Letter of Objection to the development at Former Tower Car Sales, Tower Close, East Grinstead, West Sussex (now known as Whittaker House, 1 Leppard Walk) and retrospective application DM/26/1446

This application is ostensibly the same as the original application DM/26/0432; due to this I have included my original complaint letter from that application as Appendix A to this letter - I would like my original letter of complaint for DM/20/0432 to be considered in its entirety regarding this application.

Nine Recycling bins kept within the undercroft

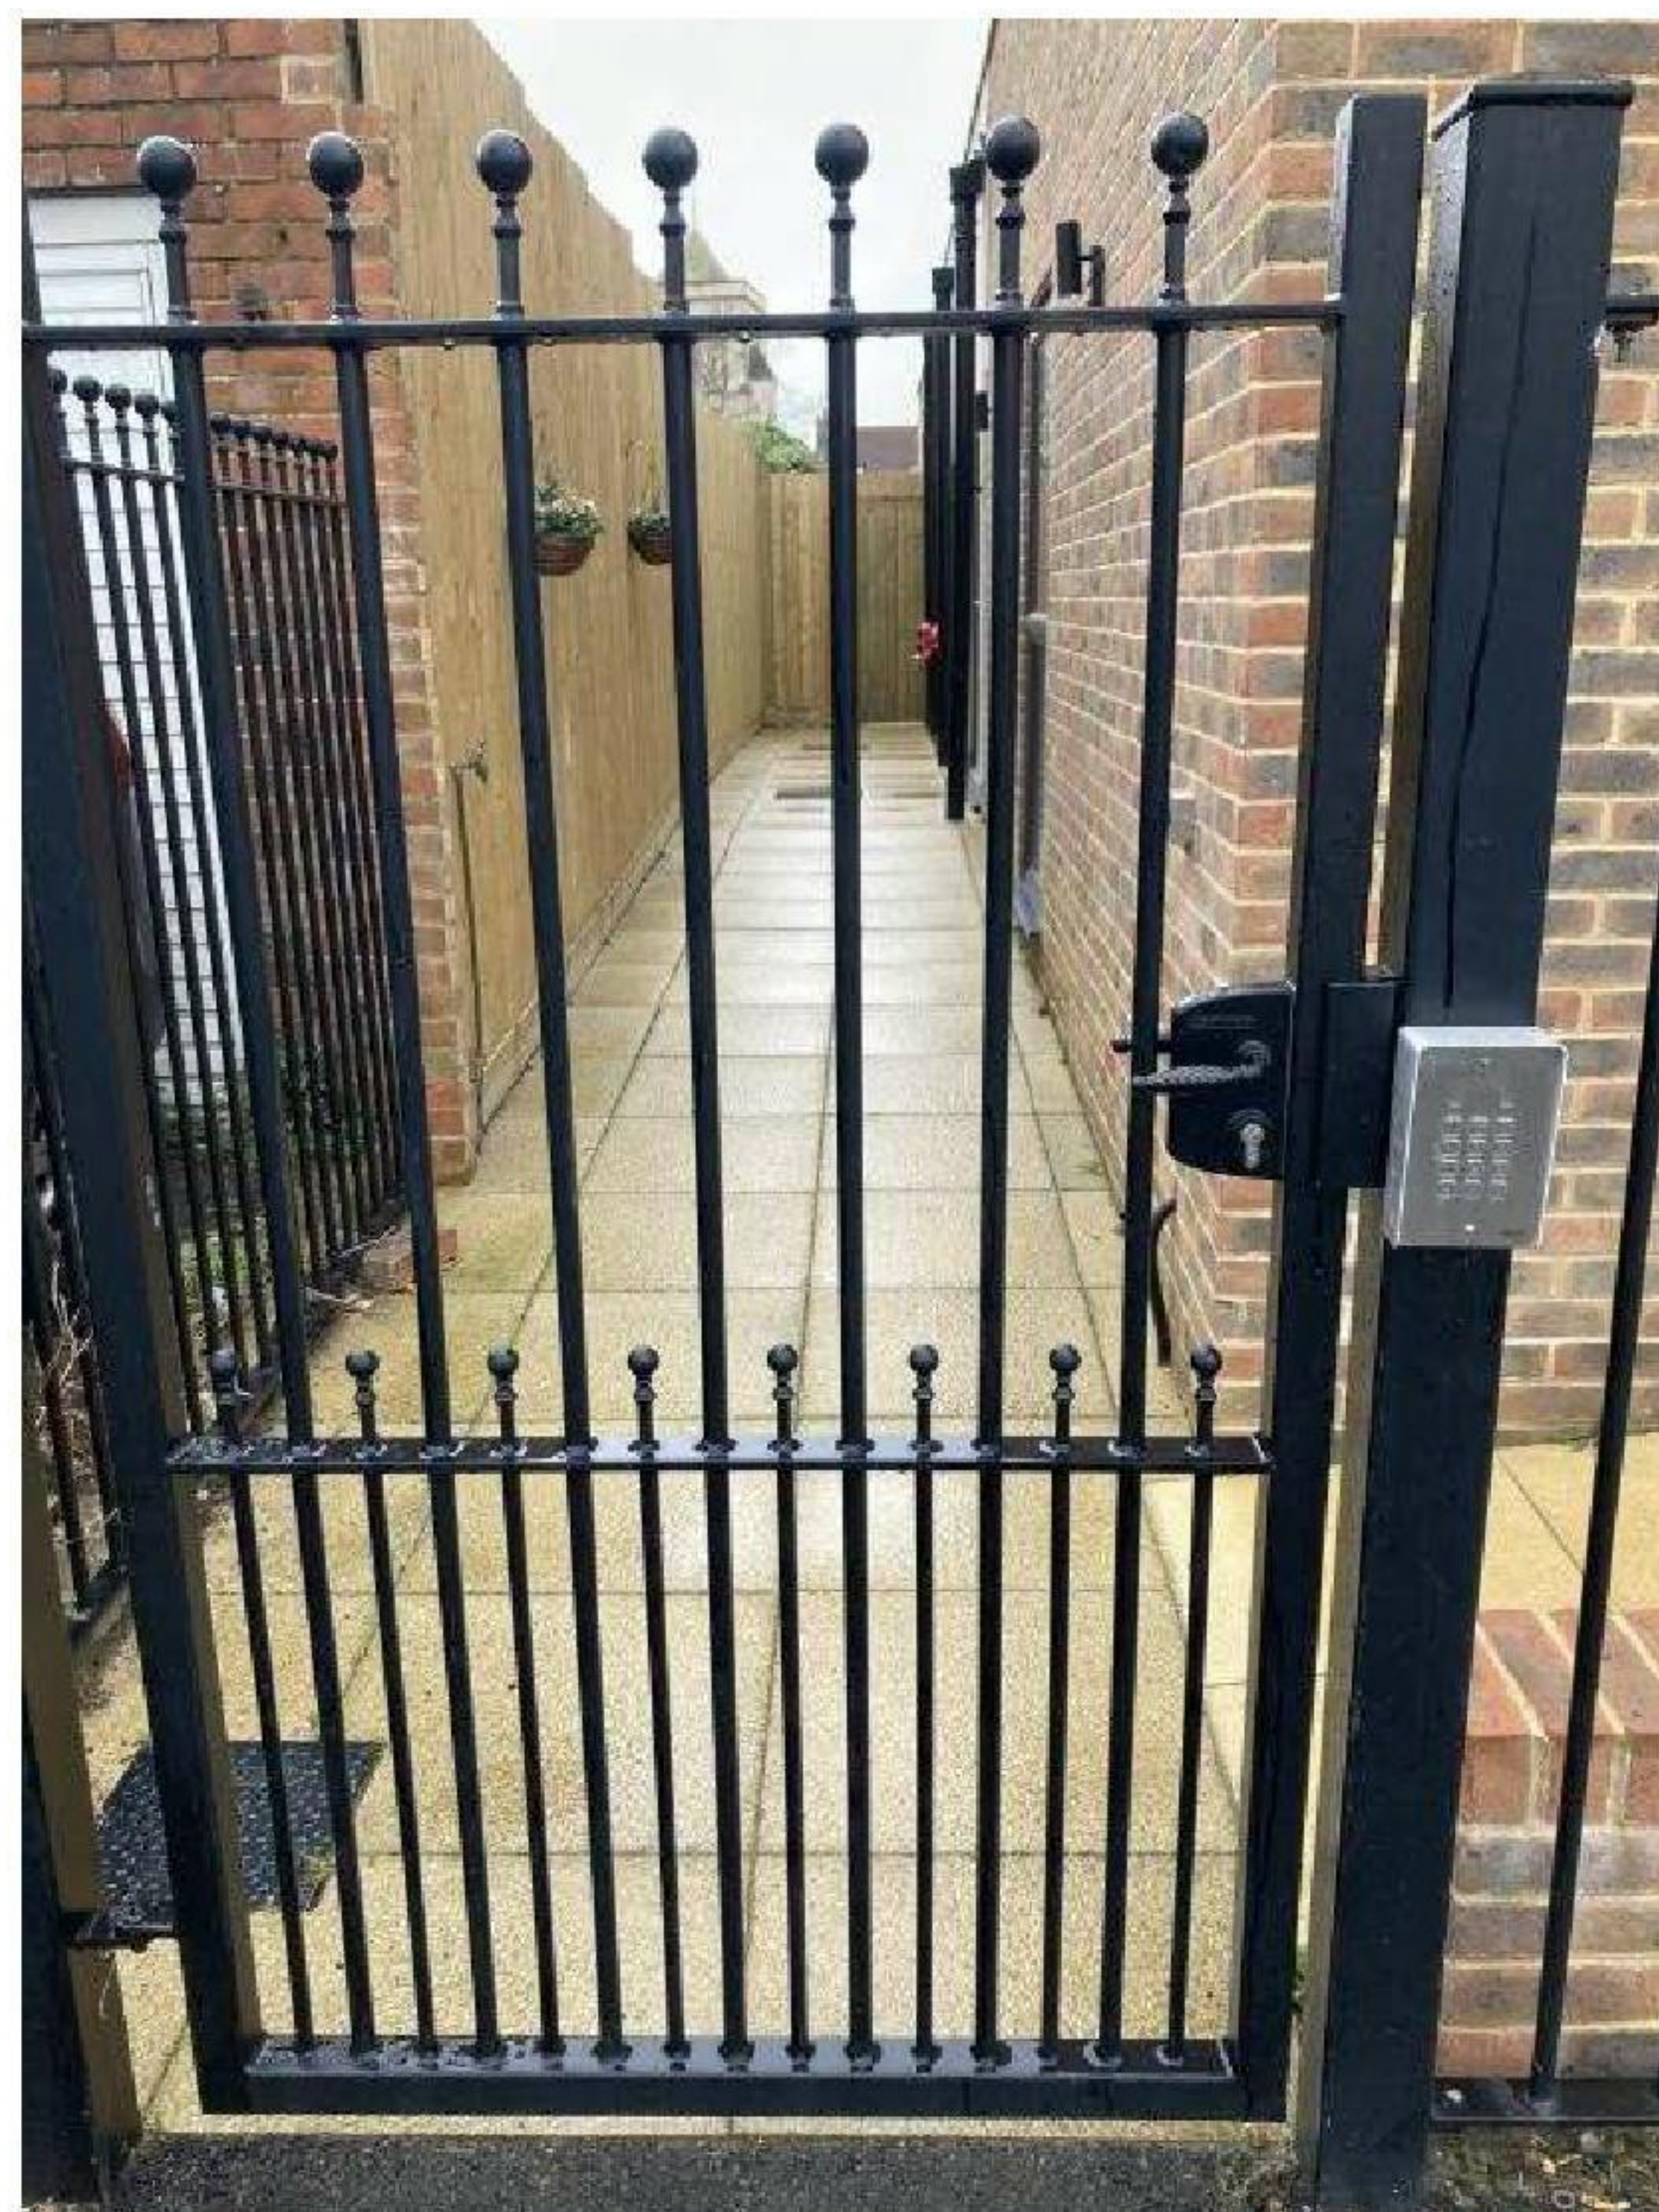
Because of the change in purpose of this entrance from main entrance to bin and bike storage, the developer encroached onto the pavement and installed a walkway, and a gate with a numeric key lock. This key lock is currently disabled, and this is the access point we use now to bring our bins to the kerb for roadside collection. The original plans had a refuse area big enough for 2 large bins, which could be accessed by the refuse collectors. Due to the developer not providing this, the development was without refuse collection for a period of nearly 5 months, as the original bins could not be sited. Following a site visit we were given 18 bins (2 per household). Half of these now live in the undercroft, representing a potential fire hazard, as there is nowhere else for them to go. We currently await the delivery of 9 exterior foot waste caddies, which will likely also end up in the undercroft:

The opaque glass is now our back door and access to the bin and bike stores, with the electrical cupboard in place of the hallway to a dedicated entrance

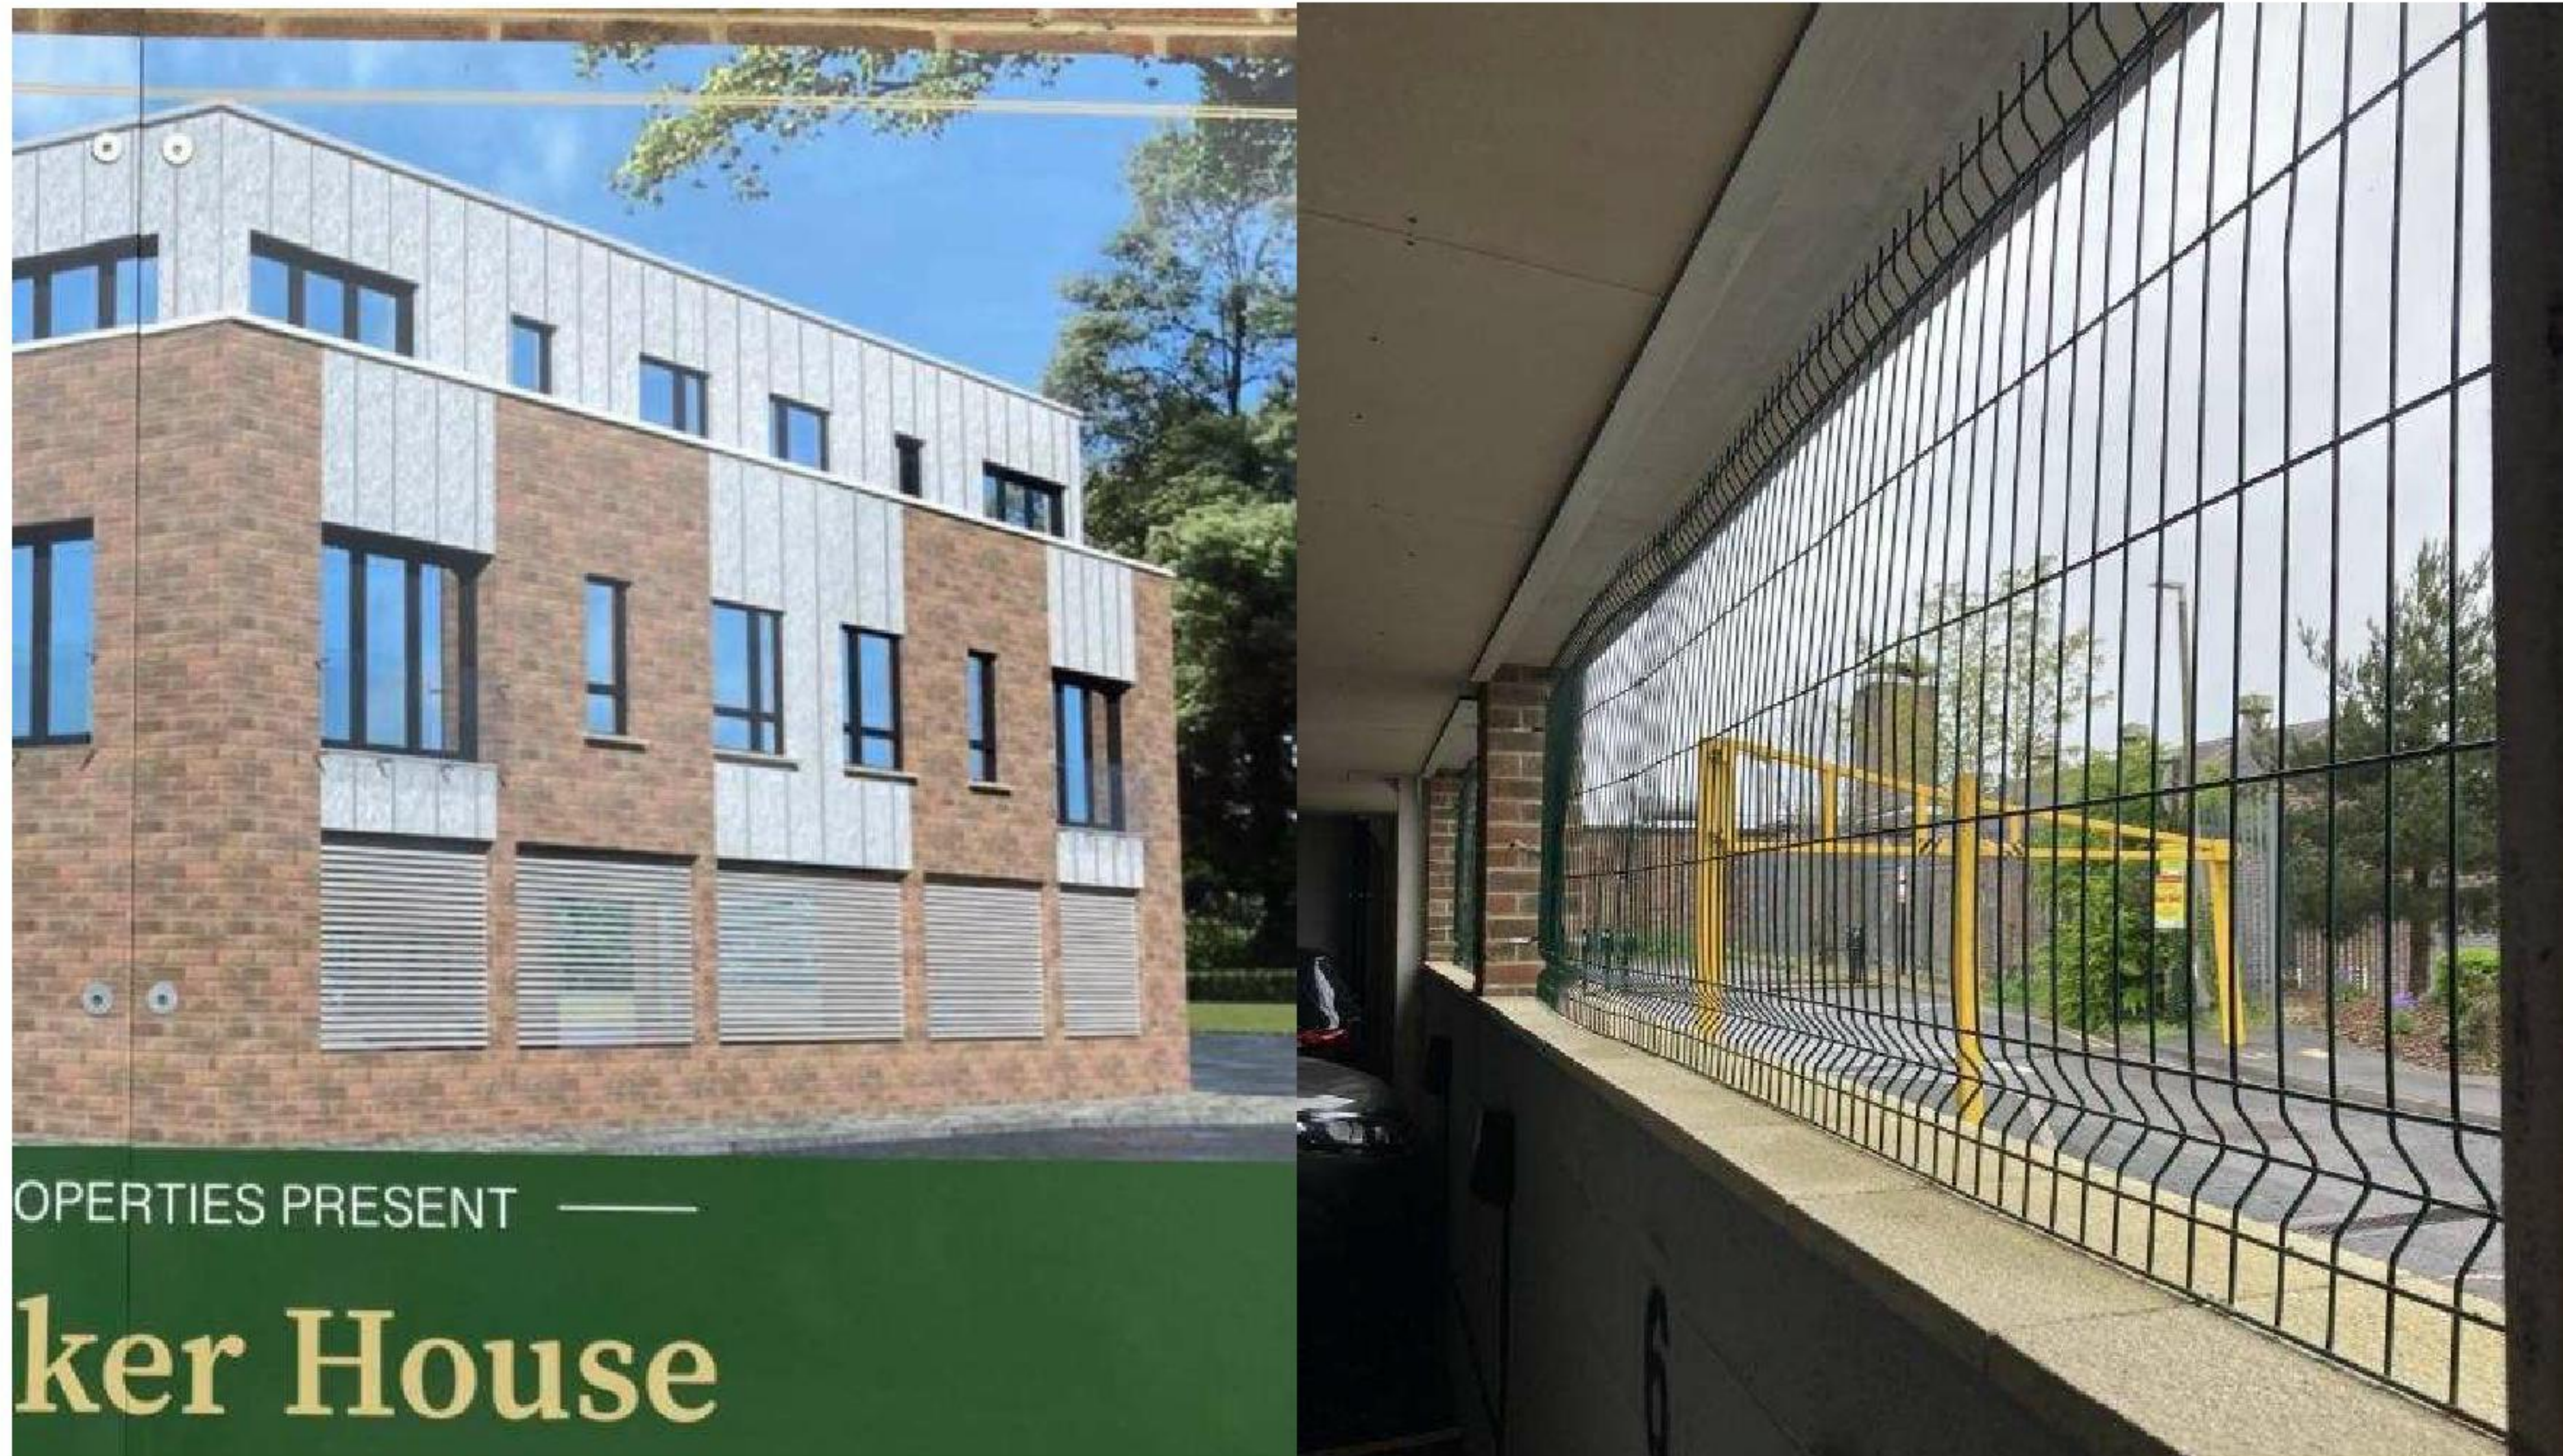
Planning permission for Whittaker House was granted on the expectation that residents would not need to enter through the undercroft, and they would have a dedicated entrance. This has also been sacrificed to make room for a potential 10th flat, with the entrance now located within the undercroft. None of the entry systems, neither internal nor external, have ever worked. The developer has been reached out to numerous times to correct this, but as of writing, no one in Whittaker House is able to receive guests, or secure deliveries, without either getting telephoned first or waiting outside the property. This is yet again more proof of the developers lack of character, and the disparity between what both we and the Planning Office were sold versus what was delivered.

The opaque glass has now been replaced with a back door, which accesses the bin and bike storage and takes us past Flat 1A's front door. The area under the stairs, which was supposed to be our hallway through to a front door, is now the cupboard where all our meters are stored. Further proof that the developer had no intention of building to plan, permission, or sales materials:

The sales poster for Whittaker House (also submitted in plans); The current car park grills

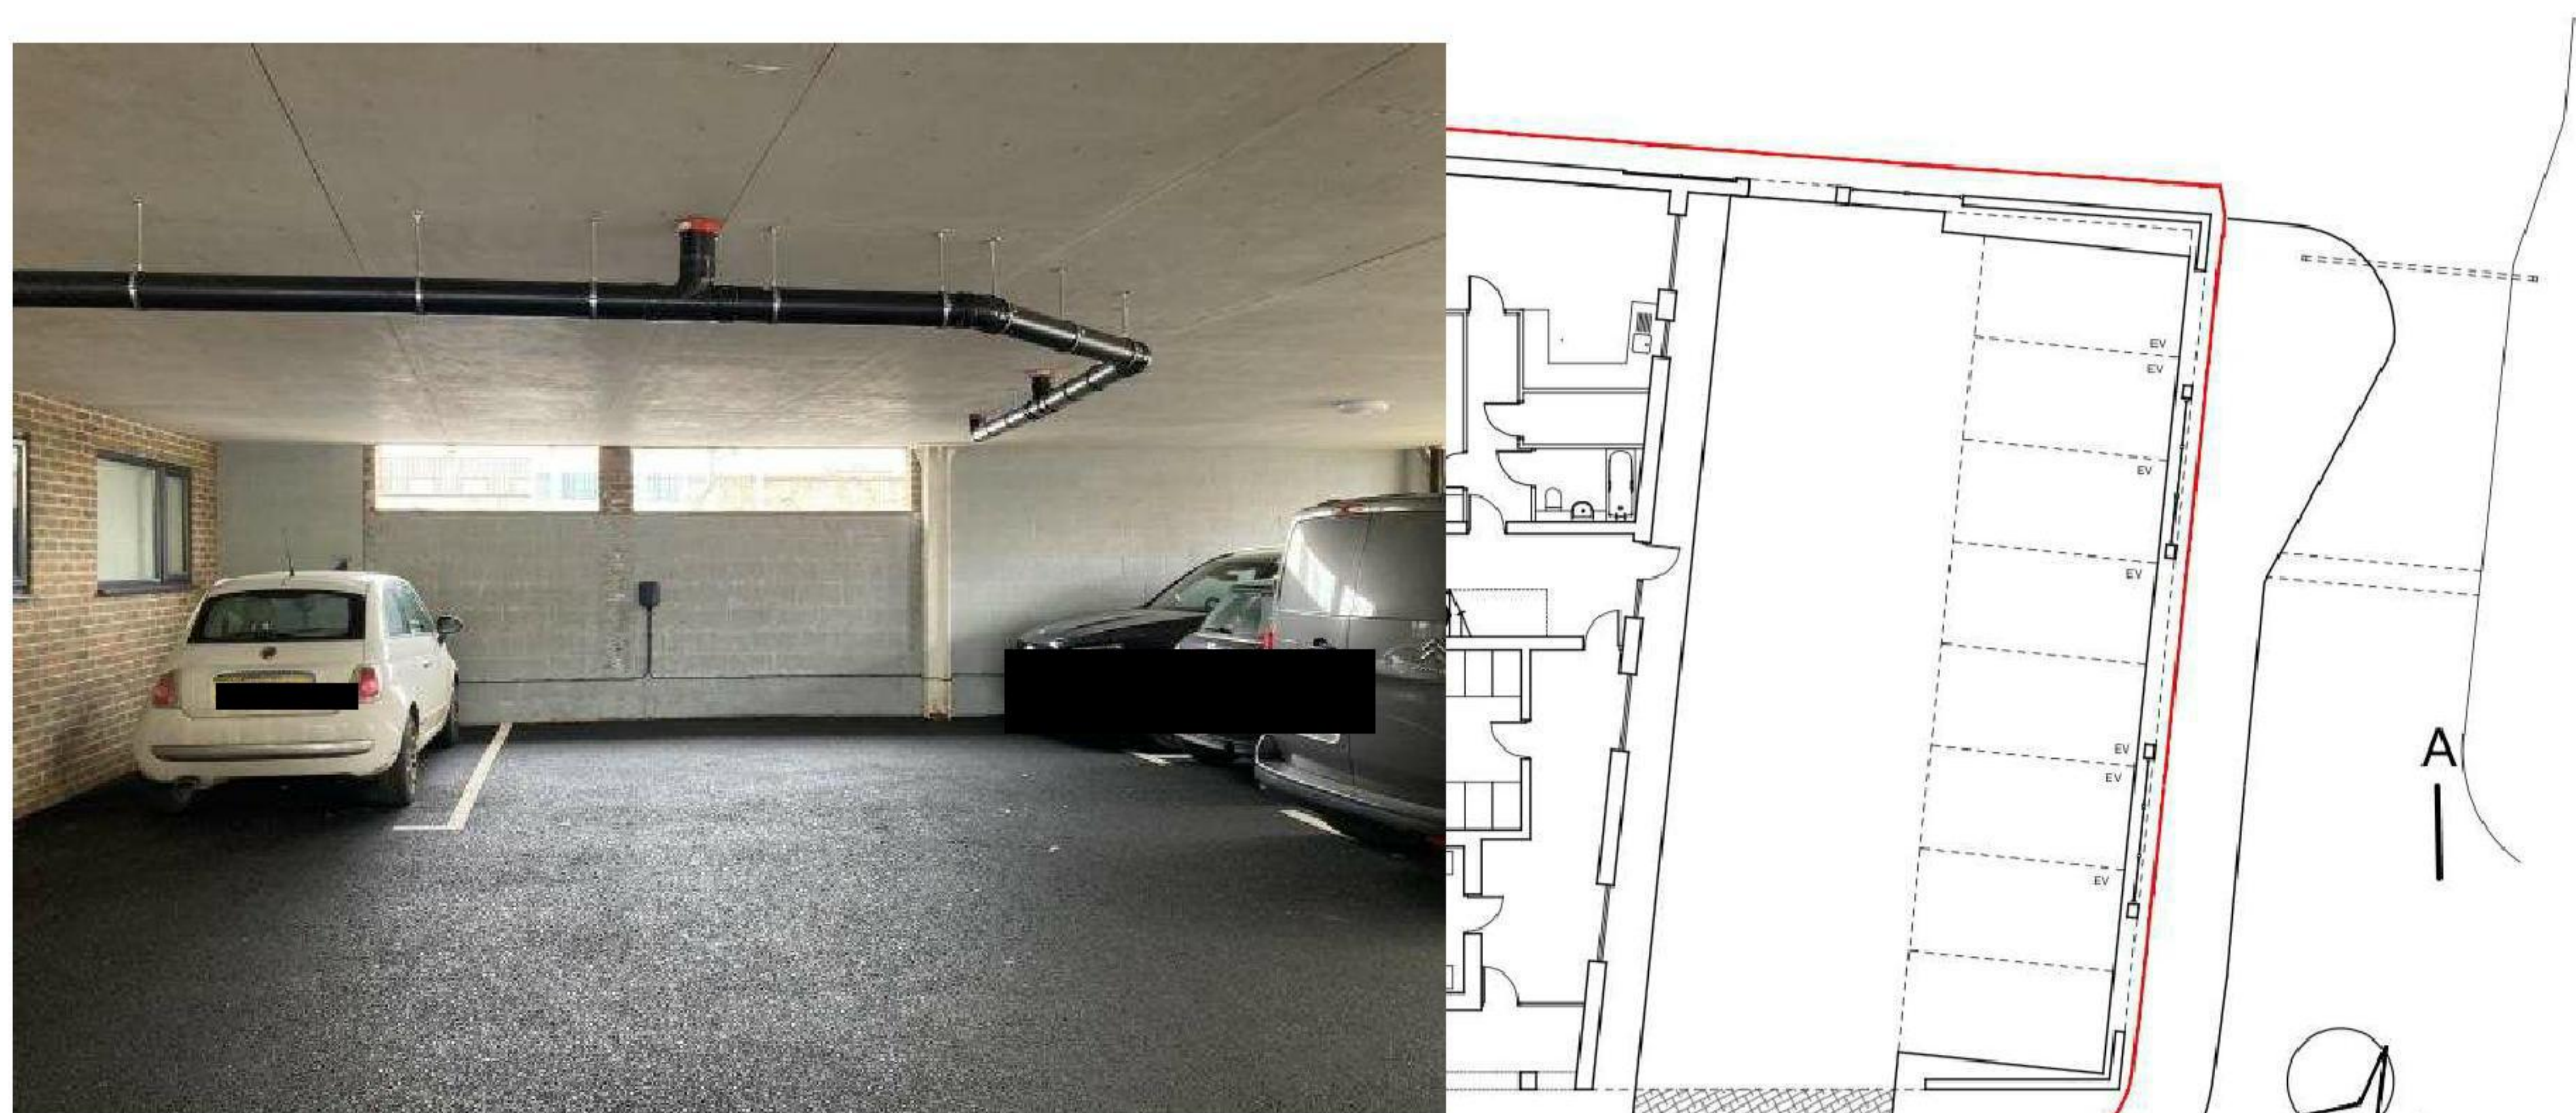
This was originally designated for 8 parking spaces, with tasteful exterior slats (or filigreed metal screens, depending on the submitted pictures). What we have been given more closely represents a snipers nest in Fallujah. This has a considerable effect on the exterior appearance of the building, and combined with the new front facing refuse area, significantly lowers the appearance of the neighbourhood:
